**DECISION, CONDITIONS, FINDINGS OF FACT, AND CONCLUSIONARY FINDINGS OF THE MCMINNVILLE HISTORIC LANDMARKS COMMITTEE FOR APPROVAL OF A NEW BUILDING AT 1025 NE 1<sup>ST</sup> STREET WITHIN THE DOWNTOWN DESIGN AREA**

- DOCKET:** DDR 1-19
- REQUEST:** The applicant has submitted a Downtown Design Review application to request the approval of the exterior design of a proposed new apartment building to be constructed on a property located within the Downtown Design area.

- LOCATION:** The subject site is located 1025 NE 1<sup>st</sup> Street, and is more specifically described as Lots 5, 6, 7, and 8, Rowland's Addition. The subject site is also identified as Tax Lot 7900, Section 21BD, T. 4 S., R. 4 W., W.M.

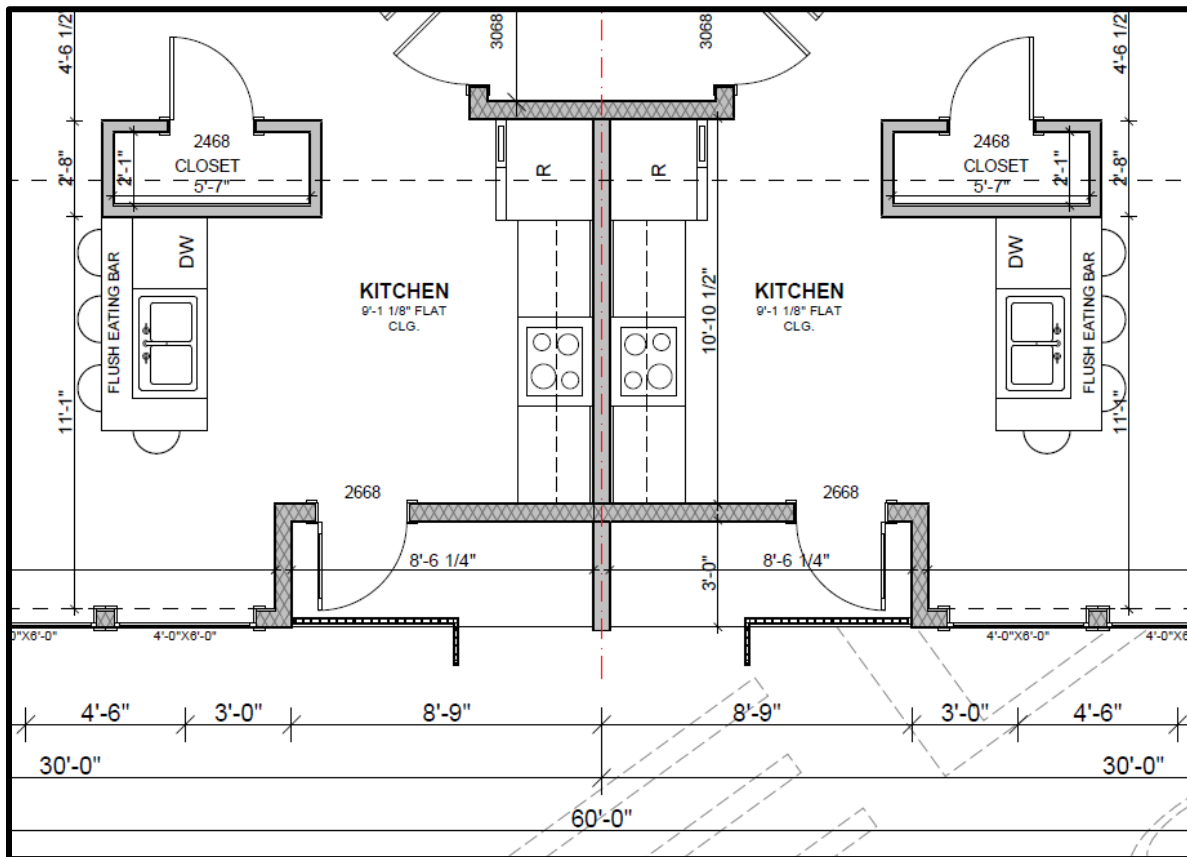
Based on the proposed design, the space being provided for the courtyards is not adequate or large enough to warrant the setback from the property line. The space is only 3 feet deep by 8 feet 9 inches wide, but over 3 feet of that width will be required to be kept clear to allow for the door to swing open into the courtyard space. This does not leave adequate room for the courtyard space to be usable as a courtyard or for dining space as stated by the applicant. The plans also include a “L” shape to the courtyard railing, which would extend out one foot into the one foot setback area. The remainder of the one foot setback area would be paved up to the building wall, which would essentially function as a 6 foot sidewalk in those spaces between courtyards. This railing configuration creates a less than desirable transition between the patio and the sidewalk, and could also present a tripping or safety issue for the public traveling along the sidewalk. The courtyard space as proposed can be seen below:

block frontage, but that would be only if an adequate space is actually being provided for a courtyard that is more usable for the future tenants. Therefore, a condition of approval is included to slightly increase the setback to allow for a more functional and usable courtyard space that could better accommodate sitting space or dining space.

Within the three (3) foot setback area, the construction plans shall be revised to include a fully fenced courtyard in front of the openings in the façade for the ground floor unit entrances. The fenced courtyard shall extend outward from the building wall up to the property line, forming a space that is a minimum of three (3) feet deep and eight (8) feet, nine (9) inches wide, that would be combined with the courtyard space under the upper story balconies. The fenced courtyard may be extended in width along the south façade of the building, if the applicant wished to have a wider courtyard space. The applicant may include gates that lock and either swing open into the courtyard or swing open off the side of the fenced courtyard into the three (3) foot setback area, based on building code requirements.

The three (3) foot setback area between fenced courtyards shall be landscaped, forming a landscape planter area between the building wall and the sidewalk within the NE 1<sup>st</sup> Street right-of-way.

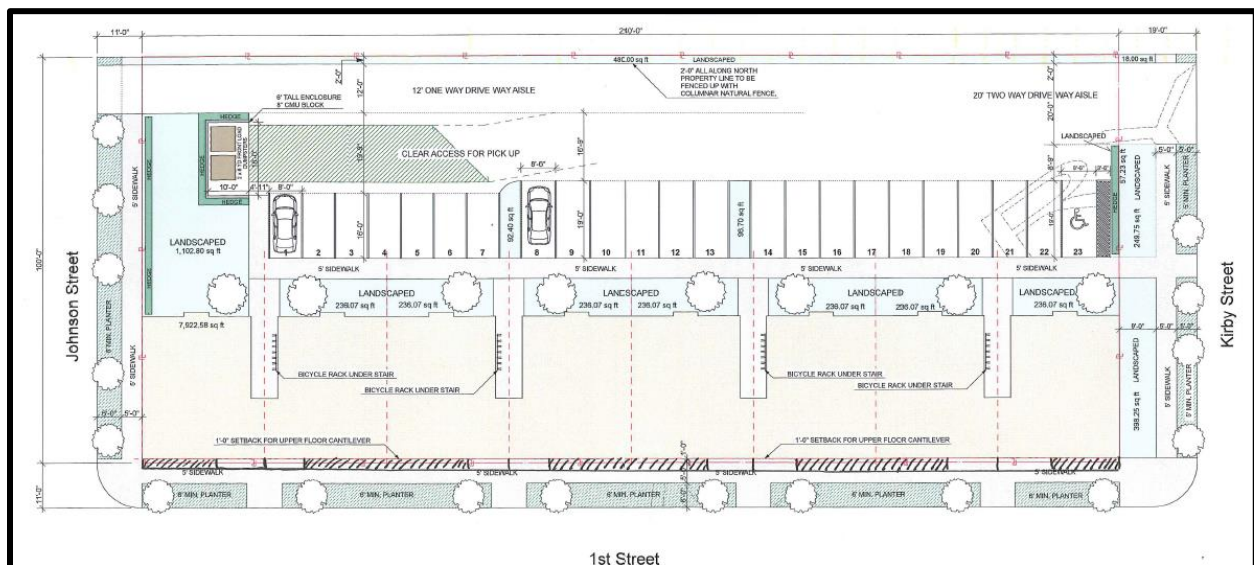
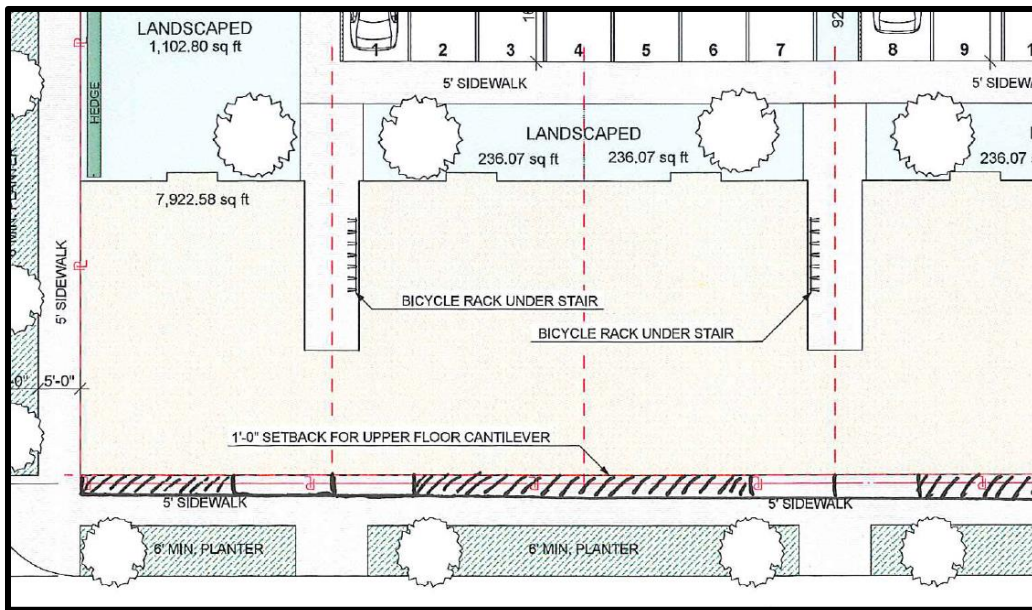
The site plan as proposed includes a landscape planting area on the north side of the building, between the north building wall and the sidewalk, which is approximately 9 feet in depth. This landscaped space could be reduced by 2 feet and still provide space for landscaping and plant materials to be placed, but would allow for the building to move 2 feet north. This would increase the setback on the south side of the building to 3 feet, but would allow for more space for a fully fenced courtyard off of the entry of each of the ground floor apartment units. This 3 foot space, along with the covered 3 foot deep space, would create a more usable courtyard area that could better accommodate sitting or dining spaces. Specifically, a condition of approval is included to require this adjustment to the placement of the building to create a 3 foot setback on the south side of the building, and that within that 3 foot setback area, fully fenced courtyards be provided at a minimum in the space in front of the opening in the façade that makes up the currently proposed courtyard and balcony areas, and that the remaining spaces between fenced courtyards be landscaped. This type of design would not only create a more usable courtyard space for the future tenants of the ground floor units, but that it would also create an opportunity for more interaction and activity between the proposed residential uses and the public space on the sidewalk on NE 1<sup>st</sup> Street.

An example of what is required by the condition of approval can be seen below. The drawing is not to scale, but represents the general design described above. The solid black lines with open space within them represent the fence that would enclose the courtyard, and the dashed areas represent would could be landscaping space between each courtyard. Entry gates could be provided to each courtyard, which would give tenants privacy and potentially be locked. These gates may need to open off the side of the courtyard (into the areas shown as being landscaped) so that the gates did not open into the right-of-way and the sidewalk space.

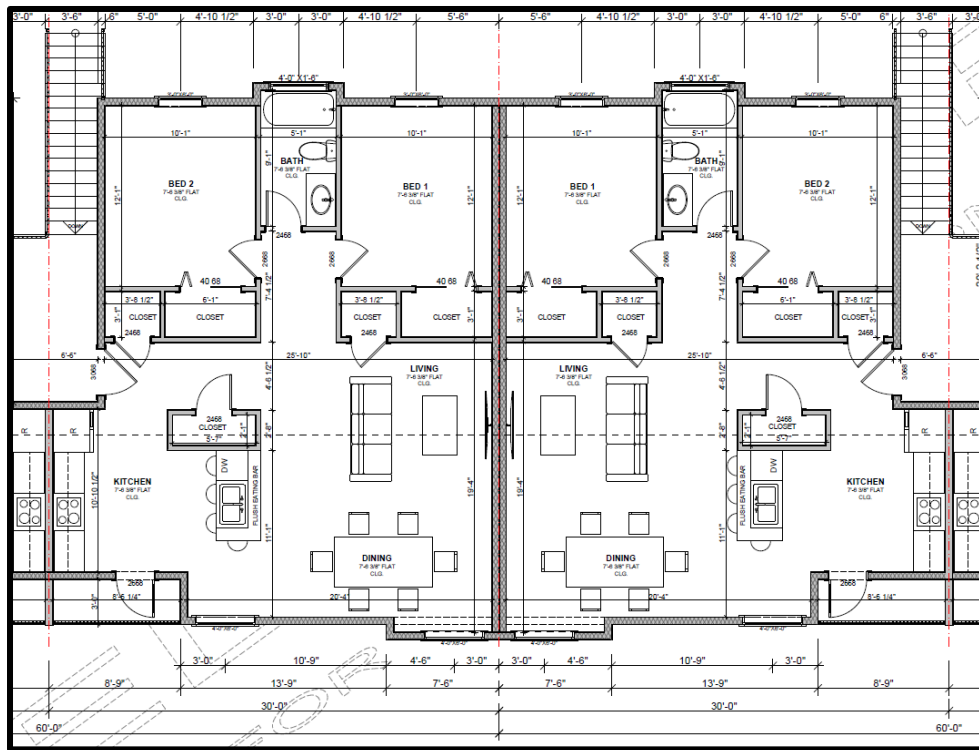
The applicant has stated that the required proportional bays are being created in the front façade by the openings in the front façade for the courtyard and balconies on the lower and upper story apartment units. These openings occur at four points along the front façade, with no more than about 43 feet between the courtyard/balcony openings. In addition to those openings, the applicant is proposing to include vertical reveal joints between stucco paneling to provide for additional vertical division and detailing along each building façade. The application narrative notes that a similar design treatment was approved for the Atticus Hotel building, and the proposed vertical reveal joints will be the same width as was applied on the Atticus Hotel building at 4 feet. Finally, the front façade is also proposed to include architectural projections along the upper story in two locations. These architectural projections are in the form of a one foot bump out, at 15 feet in width, in the area of the dining rooms on the interior of the building. The projections will again only occur on the upper story of the front façade, so the ground floor would be one flush and continuous wall (outside of the openings for the courtyard spaces). These architectural projections can be seen in the floor plan and the renderings below:

The proposed design does include a wider space along the center of the south (front) façade. That space is currently shown as one flat wall, approximately 43 feet in length, between two openings for courtyards and balconies. In order to provide for a more consistent pattern and rhythm along the south façade, and to ensure that the vertical divisions and detailing are being provided along the entirety of the south façade, a condition of approval is included to require that one additional architectural

projection, identical in size and design the two included in the proposed design, be provided in the center of the south building façade. The condition specifies that this third architectural projection would extend outward from the dining room spaces within the two most interior apartment units on the upper story of the building. The location of this required third architectural projection can be seen below:

3. That the construction plans shall be revised to include a third upper story architectural projection, identical in size and design to the two (2) included in the proposed design. This third upper story architectural projection shall be located in the center of the south building façade, extending outward from the dining room spaces within the two most interior apartment units on the upper story of the building.
4. That the construction plans shall be revised to include a more defined transom on the ground floor apartment unit entrances that open onto the NE 1<sup>st</sup> Street right-of-way.

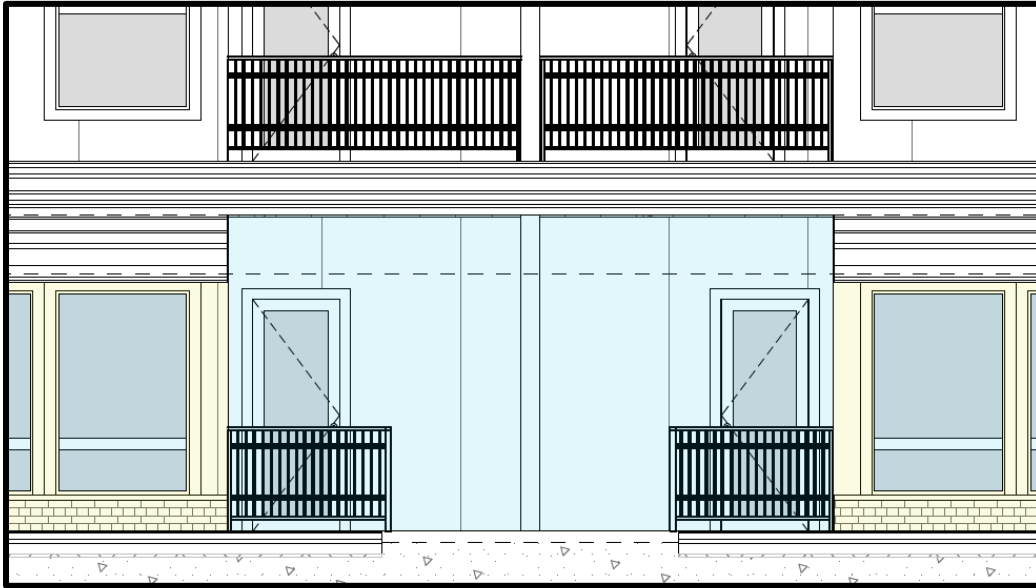
building's ground floor façade and 51 percent of the building upper story façade are proposed to be glazing, between all of the windows and the openings in the façade for the courtyard and balcony spaces. The ground floor apartment units include entryways that are recessed under the balcony spaces above. These entryways include what is described in the application narrative as “transom with a transparent front door”, and those transparent doors are identified in the front elevation. However, an obvious transom is not visible in the renderings on these entry doors. A typical trim around the door is identified in the elevation, which can be seen below:

A condition of approval is required that the final construction plans be revised to include a more defined transom on the ground floor apartment unit entrances that open onto the NE 1<sup>st</sup> Street right-of-way.
